ATTACHMENT O: PUBLIC PROCESS AND COMMENTS BEFORE JUNE 2019

PUBLIC COMMENTS AND CONCERNS

| SHEET 8 OF 9 DRAWING NO. M-01 | CIVIL PUMP HOUSE MECHANICAL PLAN | | SALT LAKE CITY PUBLIC UTILITIES 4TH AVE WELL AND BRICK TANK SALT LAKE CITY, UTAH | | PRELIMINARY |

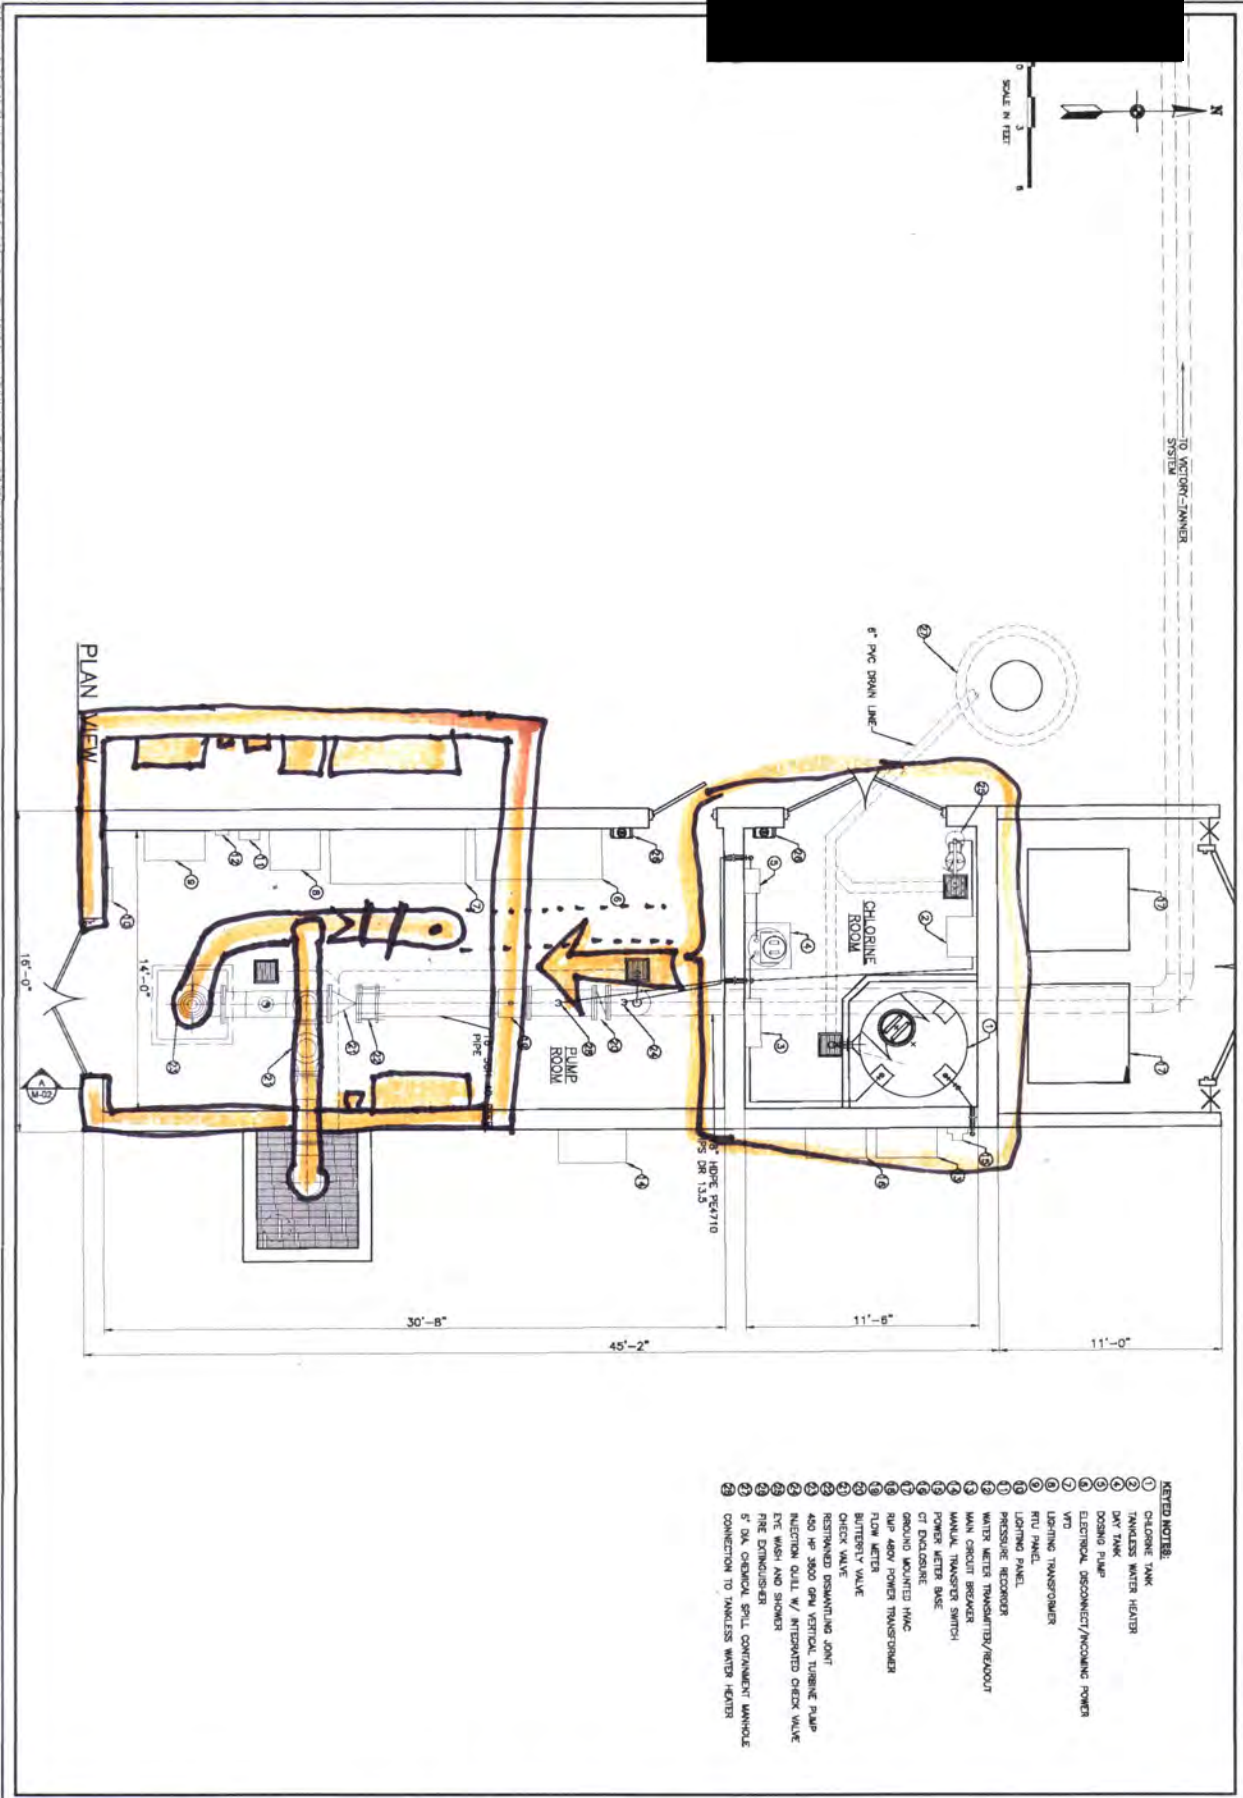
Utilize Magnetic Flow Meter* to remove
the upstream & downstream pipe lengths for
laminar flow of existing Meter. If interior
electrical cannot be shrunk, expand building
to west by 1-2ft to provide clearance between pipe
& electrical on east wall. IF this will impact
the tree then present two alternatives 1) Loge tree
w/ smaller building

Figure 1 – Schematic of Applicant’s Proposed Option B Design near 61 East North Temple. Compare to DPU Architectural Renderings in Figure 3 and Figure 4, below.

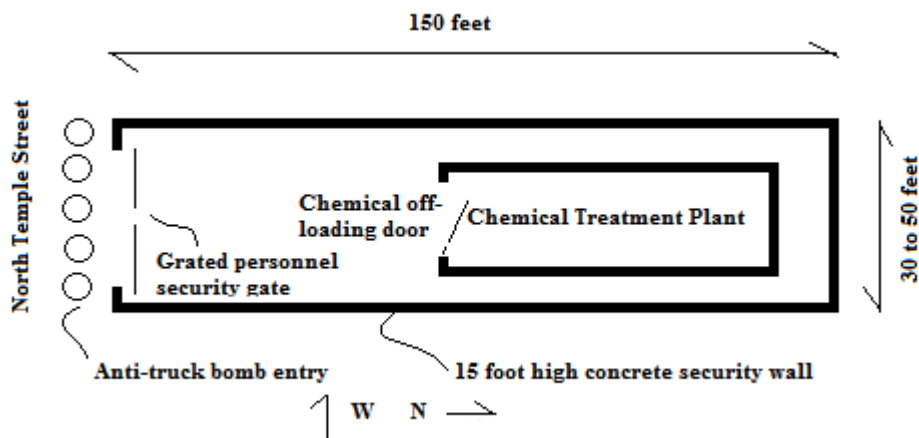
Option 6: Your applicant believes that once informed with the potential for a plausible terrorist attack on the DPU proposed Well design, described below, that the Church of Jesus Christ of Latter Day Saints would be willing to donate land at the west end of a vacant lot at the northwest corner of the nearby intersection of State and North Temple Streets¹³ for a more terrorist resistant chemical facility. The Church’s Worldwide Headquarters that offices over 1,000 persons is across the street and is within one-quarter mile of the DPU’s proposed chemical treatment facility. In this option, a water transmission line would be constructed from the existing wellhead to the new site. A utilitarian concrete structure similar in foot print to the DPU’s current design, would be surrounded by a 15 feet tall steel re-enforced concrete wall. Street access for sodium hydrochlorite deliveries would be from North Temple Street via an anti-truck bomb resistance entry. A similar anti-truck bomb resistant entry is used at the cash delivery bay at the Federal Reserve Bank at the southwest corner of 100 South and State Street, Salt Lake City. At the Federal Reserve Bank, electrically driven subsurface posts are normally extended upward and are only lowered when armored car deliveries occur. The following figure shows a schematic of this Applicant proposed alternative:

Figure 10 – DPU Architectural Rendering showing that despite known flooding risk power transformers are located at the north-upstream end of building and that proposed structure is built at grade. May 9, 2019.

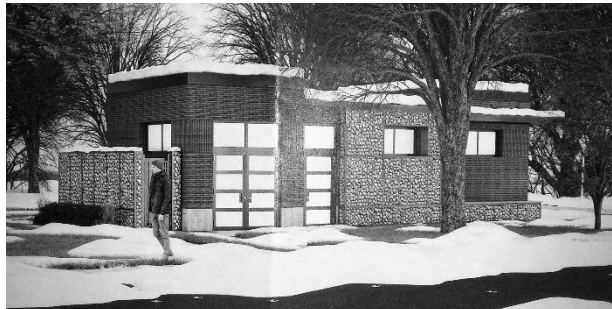
The concept design (Figure 10) does not consider the flooding history at the 400 North site. The chemical plant is built at grade and not above the last known flood levels. The rectangular north end of the plant includes high-power transformers at ground level. The transformers will put residents and first responders in future floods at risk of accidental electrocution. Because the building is rectangular, the north narrow end will be susceptible to having its foundation undermined and suffering a structural collapse. If a collapse occurs during a flood, the chemical storage tank inside the building may fail and release 500 to 900 lbs. of sodium hypochlorite into floodwaters. Such a spill, in addition to creating a risk for chemical burns, may by simultaneous mixing of large a volume of sodium hypochlorite into water may release a cloud of chlorine that would be a health risk to the surrounding neighborhood.

Figure 4- Concept schematic of the proposed facility from above and side.

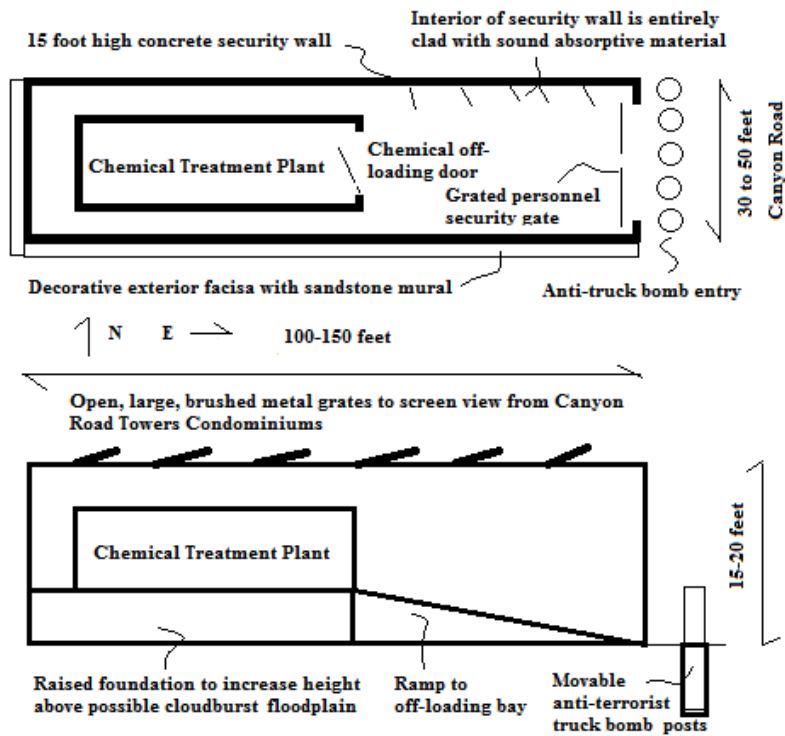
Figure 4 illustrates an anti-terrorist facility that is more resilient than the DPU’s current concept design. Aesthetic features to make the facility better blend in with City Creek Park and the surrounding neighborhood include:

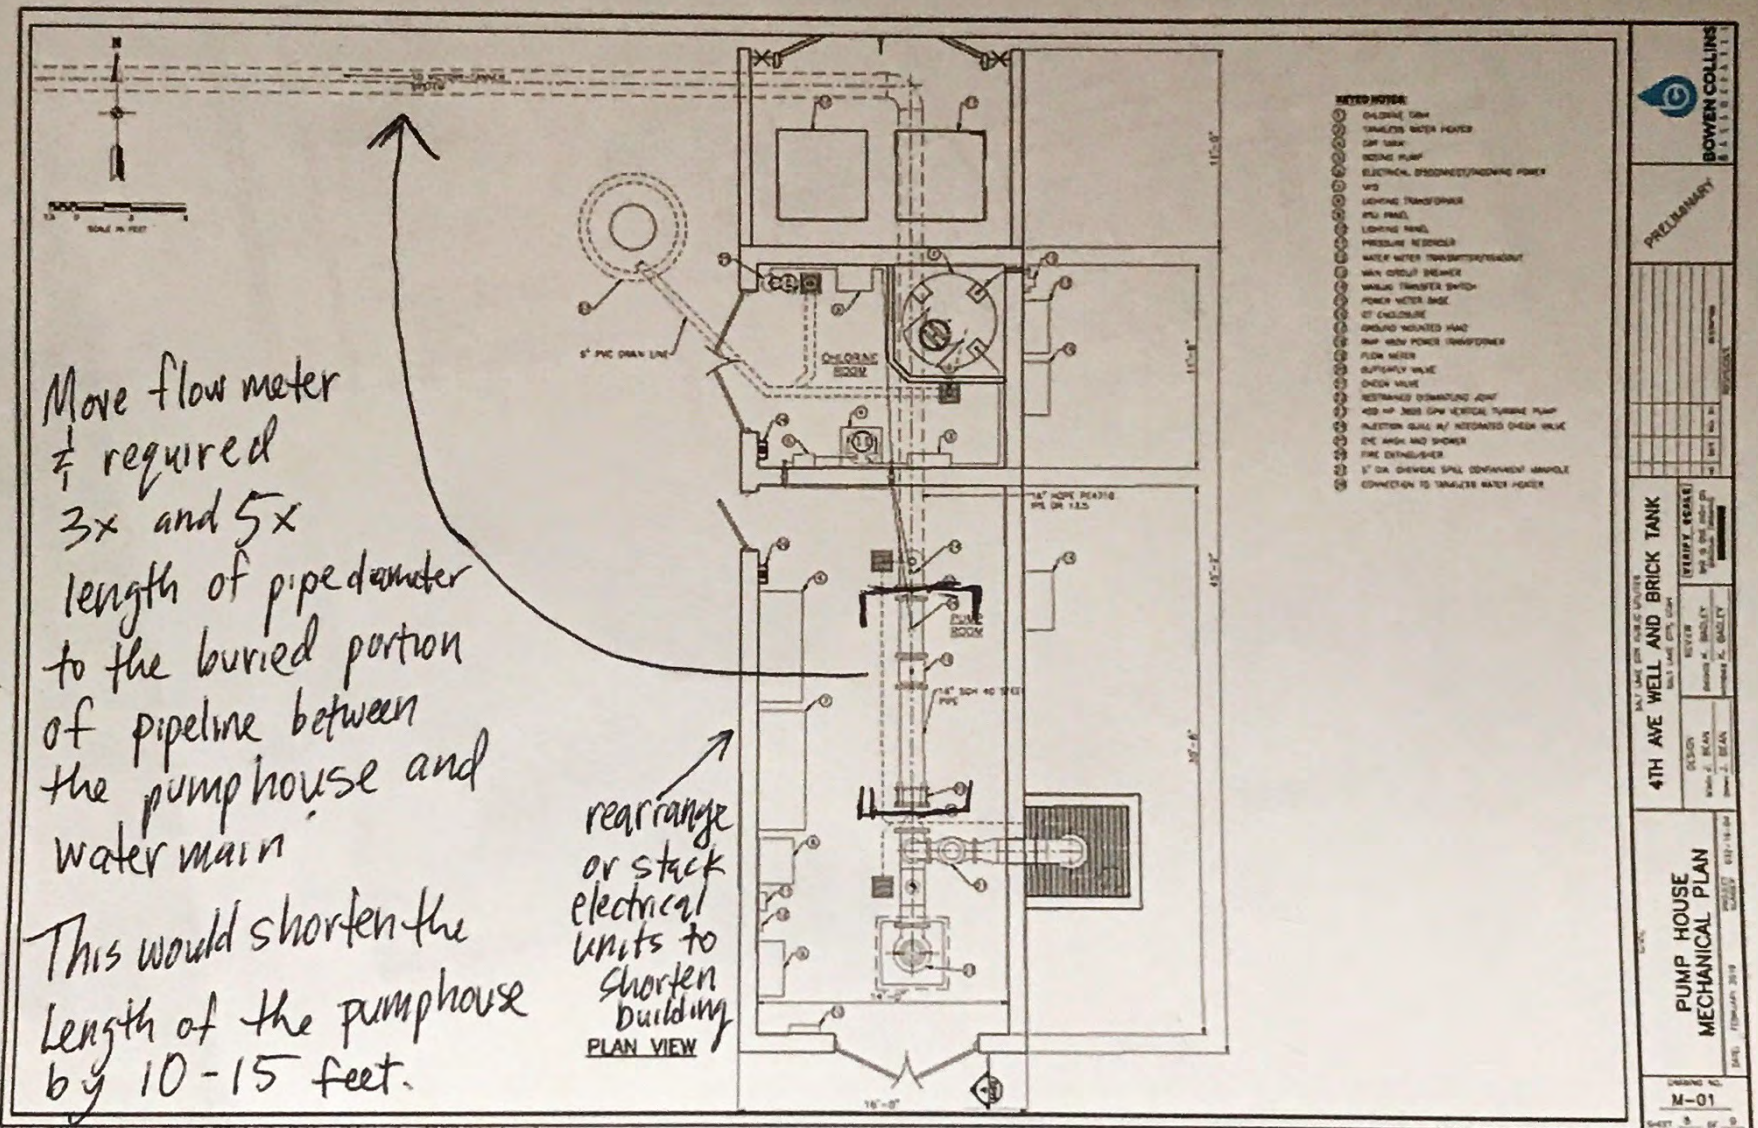
Access the flow meter by man hole or similar in the street if ever needed for inspection/replacement/maintenance
